SB No.	A/C Models	Aviation	Details (Para)	Issue Date
1	B series	Factory Recommended	Replacement u/c fibreglass rods	01/03/85
2	B & B-D	Factory Mandatory	Replace foam intake filter with Rotax muffler MOD 008	23/03/86
3	B & B-D	Factory Mandatory	Test mainwheel axles for cracking	23/12/86
3a	B & B-D	Factory Recommended	Rotax 447 cooling shroud with internal deflector	01/06/87
4	B & B-D	Optional Fit	Rotax 447 redctn grbox,torsional shock absorber mods	17/07/87
5	B & B-D	Factory Recommended	Aileron control rod ends, remove, locktite 242e, refit etc.	03/12/87
6	B & B-D	Factory Recommended	Holes to assist air mass venting of wing outer 'D' boxes	01/03/88
7	All	Factory Recommended	White coloured upper surface of wings combat solar heating	21/05/90
8	All	Optional Fit	Alloy wheels	01/05/90
9	B,B-D,C,C-D,SS	Factory Recommended	Support for front hanger bracket. (Wing)	11/06/90
10	B/B-D,C/C-D,SS	Factory Recommended	Fore and aft wing movement,provision of pressure pads	06/11/90

SERVICE BULLETINNO. 1DATE 1.3.85CFM METAL-FAX LTD CONSIDERSCOMPLIANCE - ~~Mandatory~~/Recommended/~~Optional~~
(delete which is not applicable)

CFM METAL-FAX LTD
 CHANGE NOTE - SHADOW SERIES
 REF. B & B-D

FIG.1

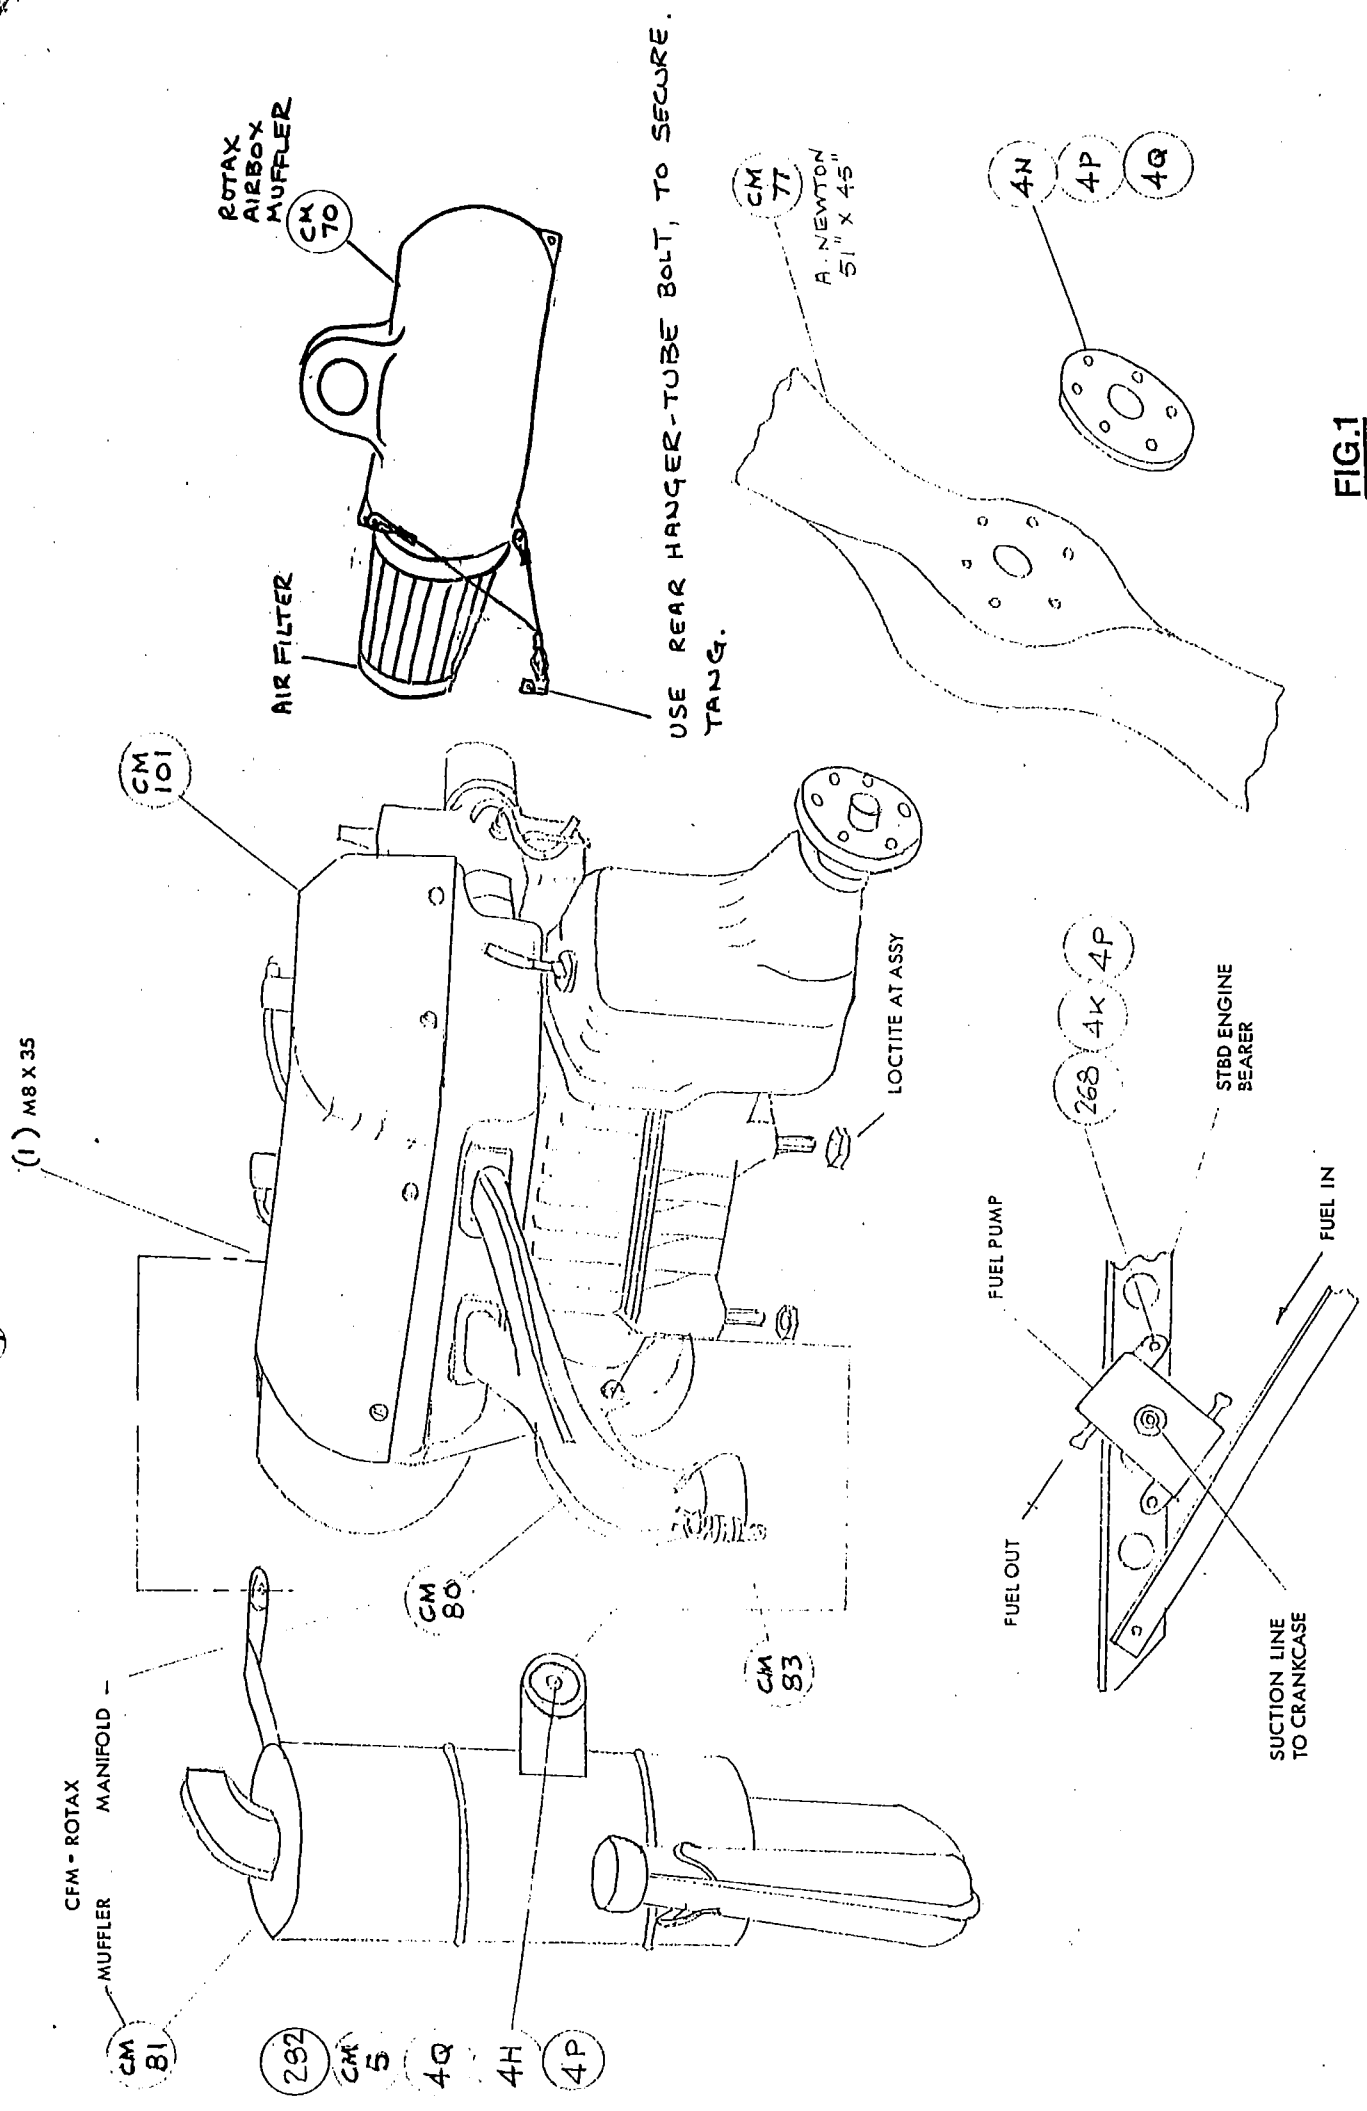
DRG MOD	PART N°	SPEC SECT	SPEC SHT	PRO. SHT ISS	DETAILS OF CHANGE	REMARKS
					<u>CHANGE DETAIL:</u>	
					REPLACE FOAM AIR INTAKE FILTER	
					ON CARBURETTOR OF ROTAX 447	
					ENGINE TO ROTAX AIR-BOX MUFFLER.	
					CHANGE MAIN JET TO N° 155	
					NOTE: THE ROTAX AIR BOX MUFFLER	
					IS A STANDARD OPTION OFFERED	
					BY ROTAX FOR FITTING TO	
					THE 447 UNIT.	
					NEWTON PROPELLER - PUSHER-CHANGED	
					FROM 51"φ x 44" PITCH TO 51"φ x 45" PITCH.	
					NOTE: PROPELLER MANUFACTURER REMAINS	
					THE SAME.	
					CONSTRUCTION, TYPE, STANDARD,	
					& PATTERN ARE IDENTICAL. ONLY	
					THE PITCH IS ALTERED.

REASON FOR CHANGE:
 TO SUIT SOUND - NOISE REQUIREMENTS
 MOD. LEVEL: MINOR.

1. Remove other foam air filter.
2. Fit new intake muffler using jubilee clip with air filter facing forwards and horizontal.
3. Fit attached lanyard to nearest (Stbd) hanger tube bolt.
4. Wire lock air filter to muffler.
5. Fit main Jet No. 155.

FIG 1A

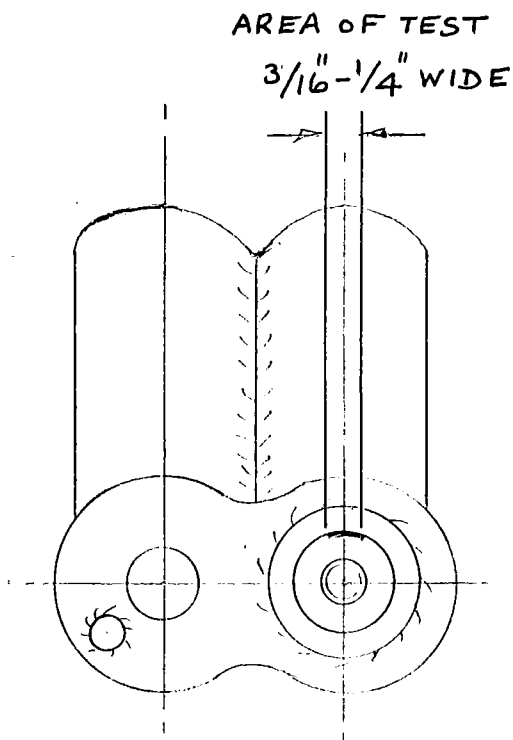
<u>SUBJECT</u>	AXLE - MAINWHEELS
<u>MODELS AFFECTED</u>	SHADOW SERIES B & B-D
<u>SERIES NOS. AFFECTED</u>	K023, 024, 026, K027, 028, 029, 030, K031, K032, 033, K034, 035, 036, K037, K038, K039, 040, K041, K043, K044.
<u>COMPLIANCE TIME</u>	MANDATORY
<u>PURPOSE</u>	TO INSTRUCT OWNERS TO EFFECT A SIMPLE ETCHING TEST ON BOTH MAINWHEEL AXLES - WE HAVE EVIDENCE OF A FAILURE WHERE AN AXLE HAS CRACKED AT THE INNER END. FAULT IS POSSIBLE INCORRECT HEAT TREATMENT.
<u>INSTRUCTIONS</u>	SEE ATTACHED FOR DETAIL OF FIELD TEST INDICATOR
<u>MATERIAL REQUIRED</u>	SEE INSTRUCTIONS
<u>AVAILABILITY OF PARTS</u>	WILL BE EXCHANGED - THERE WILL BE SOME DELAY
<u>EFFECTIVITY DATE</u>	23 December, 1986
<u>SUMMARY</u>	EFFECT CHECK AS DIRECTED. IF SUSPECT RETURN COMPLETE UNDERCARRIAGE MINUS WHEELS AND BRAKE ASSEMBLY.
<u>NOTES</u>	PLEASE PHONE US WITH YOUR RESULTS. REFER TO SERVICE MANUAL FOR REMOVING THE UNDERCARRIAGE. COMPLETE COMPONENT WILL BE REPLACED FOC - excl. FREIGHT CHARGES IF A KIT VERSION (prefix 'K') - return axle assemblies LH & RH if not already glued up.

FIELD TEST. REMOVE MAINWHEELS. LIGHTLY REMOVE A 3/16" STRIP OF PLATING OVER ENTIRE AXLE LENGTH WITH 600 GRADE WET/DRY PAPER. REQUEST CHEMIST TO MAKE UP 100cc SOLUTION OF CONC. NITRIC ACID IN METHANOL - 5 PARTS ACID 95 PARTS METHANOL. TAKE SAFETY PRECAUTIONS. WITH COTTON WOOL LIGHTLY AND EVENLY WIPE ON OVER UNPLATED STRIP. IF SURFACE AREA OF STRIP APPEARS A DULL GREY ALL OVER THEN ITEM IS SERVICEABLE. IF SHINY - PROBABLY TOWARDS THE WELD - THEN ITEM IS SUSPECT - SEE FIG. 1. IF SO REMOVE COMPLETE UNDERCARRIAGE ASSEMBLY (SEE SERVICE MANUAL) AND RETURN TO CFM. IF NOT, GREASE UNPLATED AREA FOR PROTECTION.

DRAWING No. E119

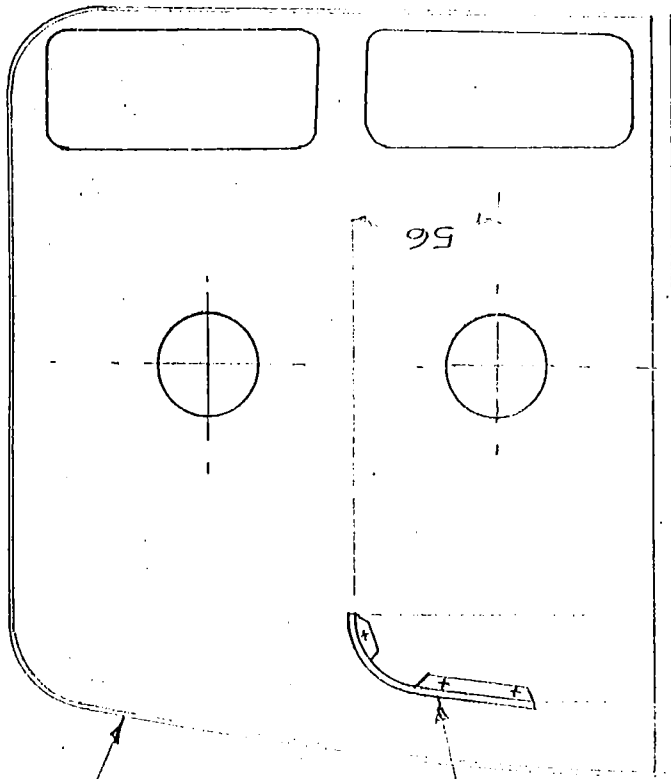
<u>SUBJECT</u>	AIR GUIDE - COOLING SHROUD
<u>MODELS AFFECTED</u>	ALL SHADOW AIRCRAFT FITTED WITH ROTAX 447 ENGINE
<u>SERIES NOS. AFFECTED</u>	B and B-D
<u>COMPLIANCE TIME</u>	FIT AS SOON AS POSSIBLE
<u>PURPOSE</u>	TO REDUCE THE TEMPERATURE DIFFERENTIAL BETWEEN THE FRONT AND REAR CYLINDERS.
<u>INSTRUCTIONS</u>	STUDY DRAWING PROVIDED. ATTACH AIR GUIDE TO INSIDE OF UPPER COWLING WITH 1/8" DIA. POP RIVETS.
<u>MATERIAL REQUIRED</u>	ENCLOSED: (1) AIR GUIDE (3) 1/8" POP RIVETS
<u>AVAILABILITY OF PARTS</u>	EX. STOCK
<u>EFFECTIVITY DATE</u>	23rd JUNE 1987
<u>SUMMARY</u>	CFM METAL-FAX REPORTED TO ROTAX THAT THE FRONT CYLINDER HEAD TEMPERATURE EXCEEDED THEIR STATED LIMITS. ROTAX SIMULATED TRIALS WITH '447' AS FITTED TO THE SHADOW AIRCRAFT. THEY REPORTED THAT THERE IS NO INSTALLATION PROBLEM IN RESPECT OF THE REAR FUSELAGE WALL SHIELDING.
<u>NOTES</u>	ROTAX ADVISE THE FITMENT OF THIS AIR GUIDE TO REDUCE THE TEMPERATURE DIFFERENTIAL BETWEEN THE CYLINDER TO WITHIN LIMITS. PREVIOUSLY THE FRONT CYLINDER (MAG. END) WAS READING HIGHER THAN THE REAR CYLINDER (P.T.O. END).

AIR DEFLECTOR
(E118) AFFIX WITH
(3) 1/8" DIA FOR RIVETS
